July 10, 2014  
File: 160960698

**Reference: Notice of Technical and Project Design Changes – Grand Valley Wind Farms - Phase 3  
Wind Project MOE Ref. No. 3624-98EQPN**

Grand Valley Wind Farms Inc. (GVWF) proposes to install and operate the 40MW Grand Valley Wind Farms - Phase 3 Wind Project (the Project) in the Town of Grand Valley and the Township of Amaranth, Ontario. Site plan maps for the Project are provided as **Attachment A**. The Renewable Energy Approval (REA) application for the Project was received by the Ministry of the Environment (MOE) on June 3, 2013, and is currently under technical review.

### **Location of Alternative Access – T110 and T112**

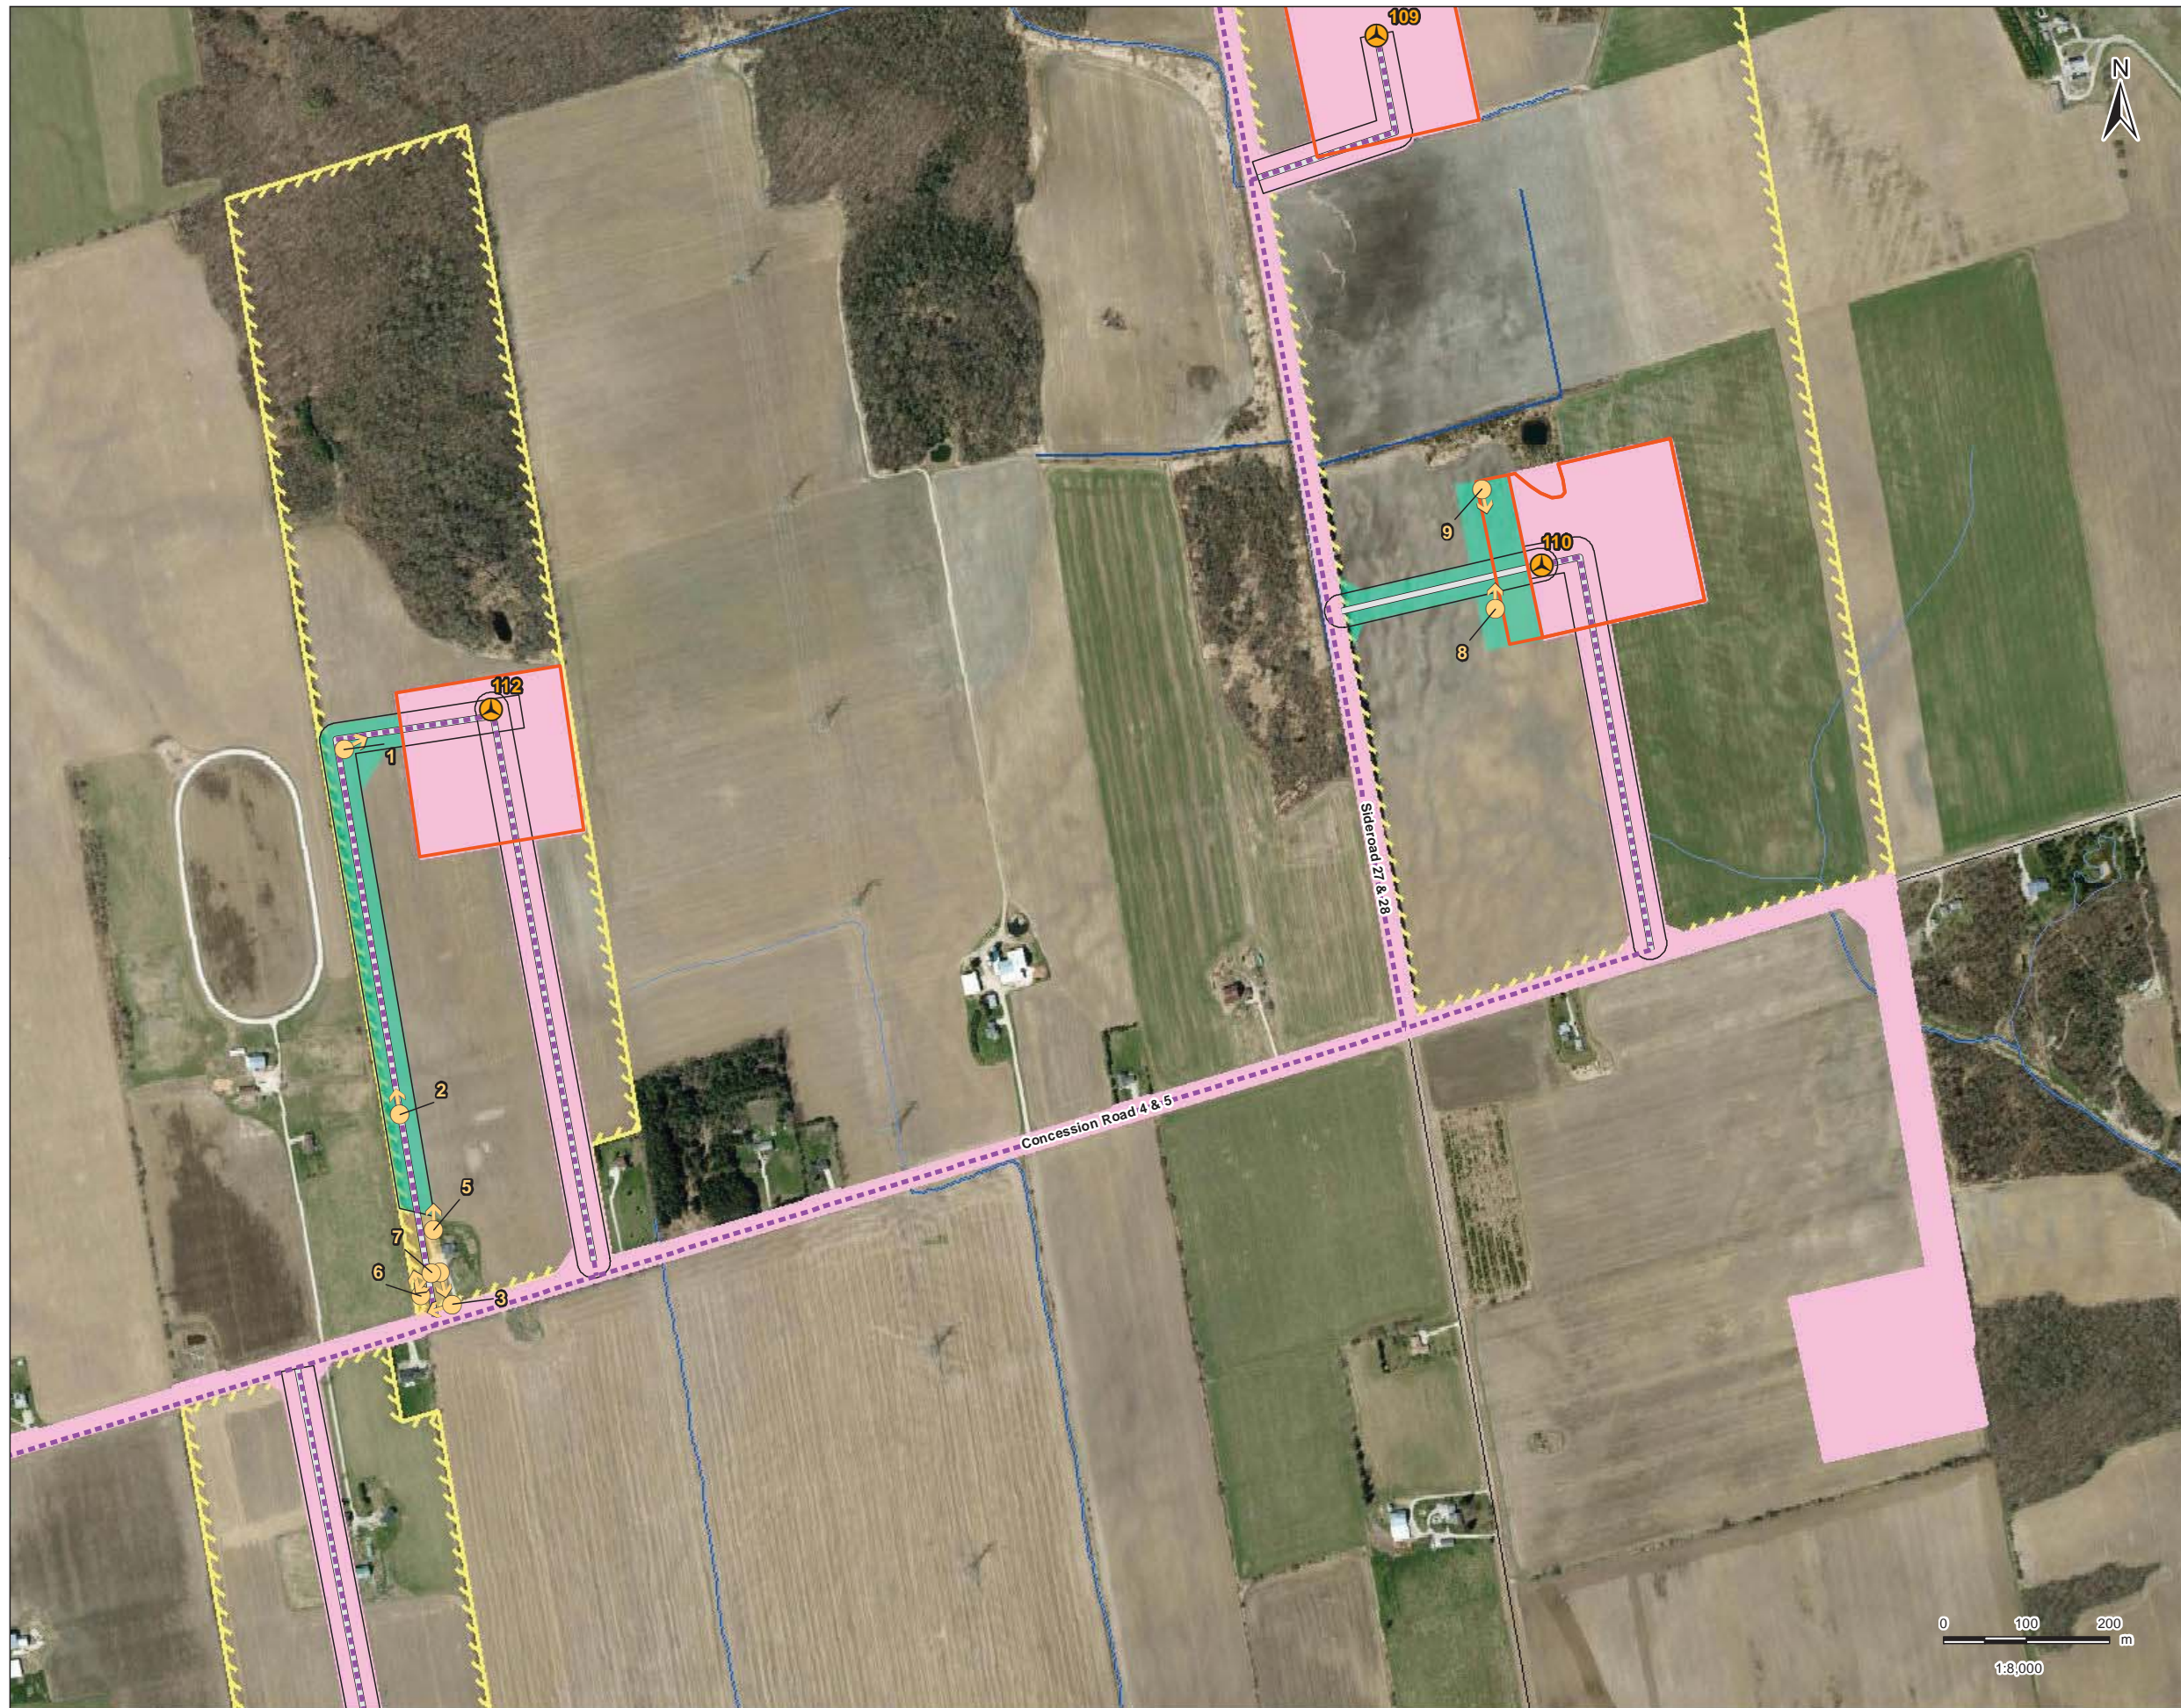
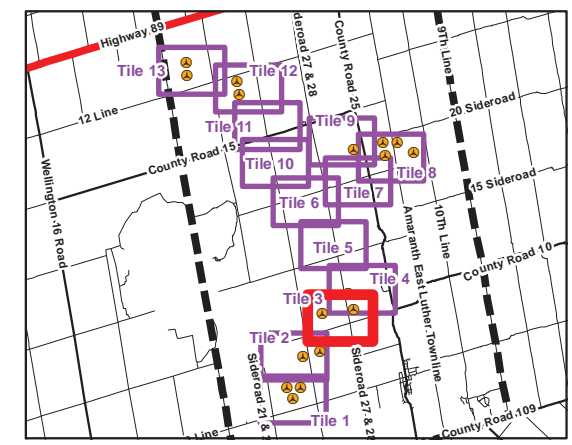
## **MODIFICATION 2 – SHIFT OF ACCECSS ROAD FOR TURBINE T112**

In the original REA application, and at the final open house for the Project, two options were presented for the access road and underground cable installation for turbine T112. GVWF would like to confirm in this Modification Document that the eastern option for this access road will be removed from the Project layout, to address concerns from the previous landowners immediately adjacent to this proposed access road. Those landowners have since sold the property, but GVWF would like to honour the discussions held with the former landowners going forward.

## **MODIFICATION 3 – MOVEMENT OF ACCESS ROAD/UNDERGROUND CABLE AND CONSTRUCITON AREA FOR TURBINE T110**

Due to the earlier removal of turbine T111 from the Project layout based on stakeholder feedback (as documented in the REA application), the original access road and underground cable location heading north from Concession Road 4/5 were deemed unnecessary. GVWF proposes relocating the access road to head east to turbine T110 from Sideroad 27/28, as shown in the Figure provided as **Attachment D**. This modification would considerably shorten the amount of road and underground cabling, thus reducing potential impacts to the agricultural field and within the municipal road right-of-way.

Title  
T110- Modification

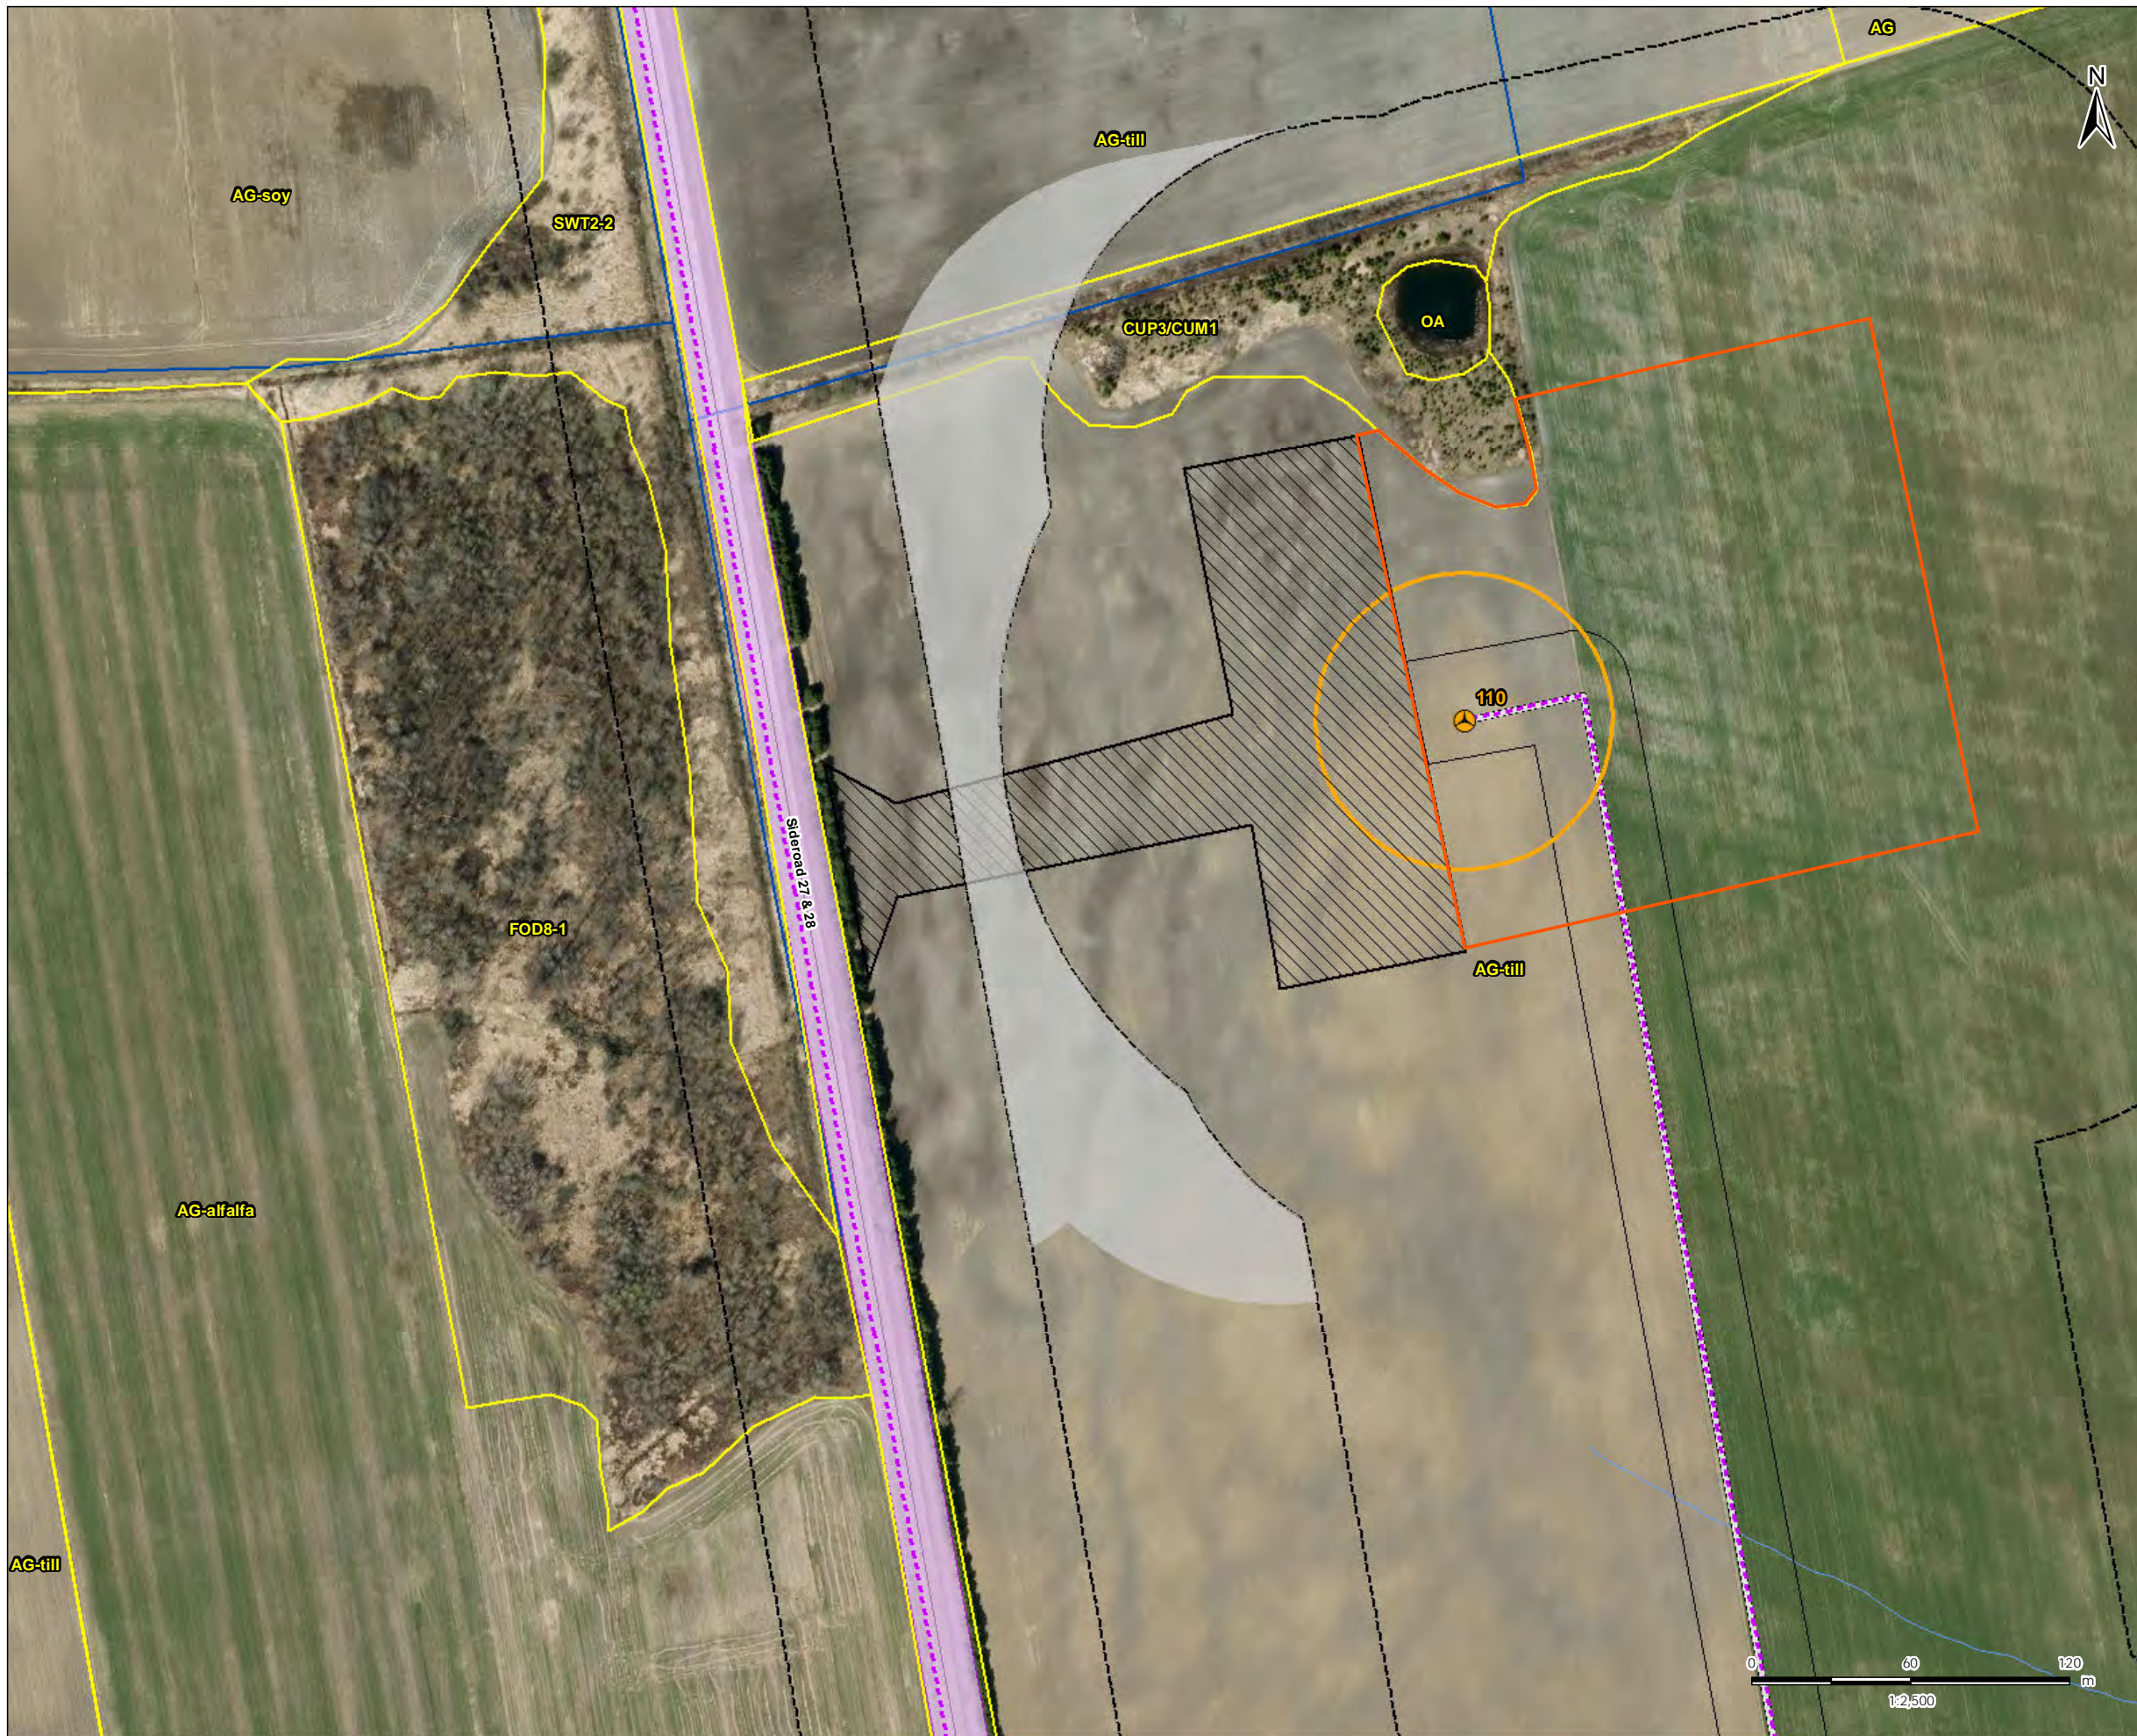
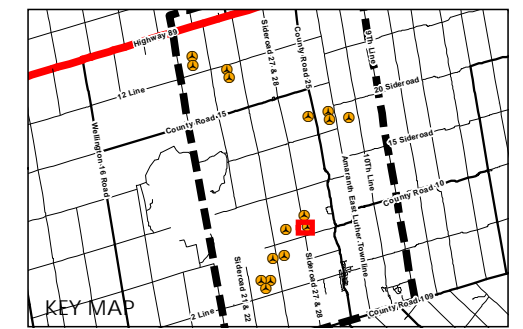
Due to the earlier removal of turbine T111 from the Project Layout based on stakeholder feedback (as documented in the REA application), the original access road and underground cable location heading north from Concession Road 4/5 were determined unnecessary. GVWF proposes relocating the access road to head east to turbine T110 from Sideroad 27/28, as shown in Figure 1 (Attachment B).

This modification would considerably shorten the amount of road and underground cabling, thus reducing potential impacts to the agricultural field. Both the original and proposed access road locations are within agricultural lands (AG-till).

The original footprint of the T110 construction area was 5.5ha; new portions of the construction area, as proposed, total 2ha. A small amount of new agricultural land will be temporarily removed due to this proposed modification, but no new natural features will be impacted, and the findings of the NHA/EIS for this area remain unchanged.

## **Attachment F Location of Expanded Transformer Station Site**

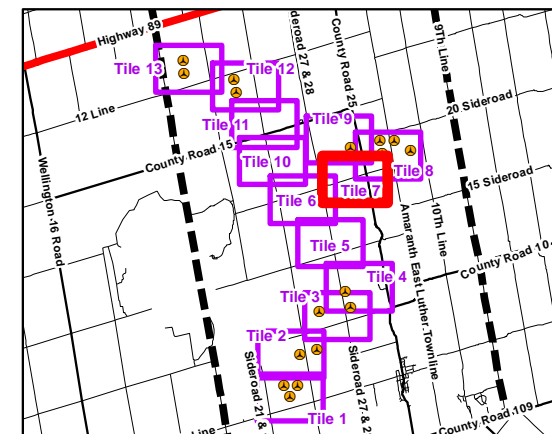
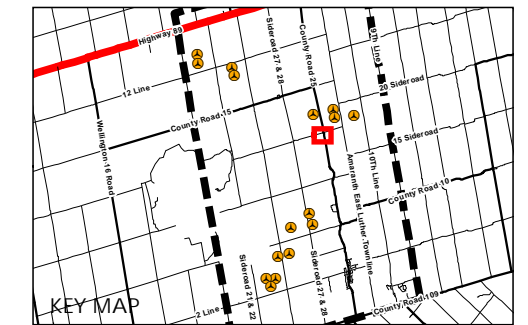
### **MODIFICATION 4 – INCREASE IN CONSTRUCTION AREA, TRANSFORMER STATION**

In discussion with their proposed construction contractor, GVWF wishes to propose an increase in the construction area required for the transformer station from 2.3 ha to 3.3 ha (see **Attachment F**). This modification would facilitate construction of the transformer station, and would also result in moving construction activities (and associated noise and construction disturbance) further from the closest non-participating residence R202, 297m from Tr119, maximum modelled noise level – 36.5dBA). The construction area for the Transformer Station will also be pushed as far back on the property as possible, but there will still be construction activities throughout the TS site (i.e., for the connection to the HONI transmission lines, construction lay down, etc.).
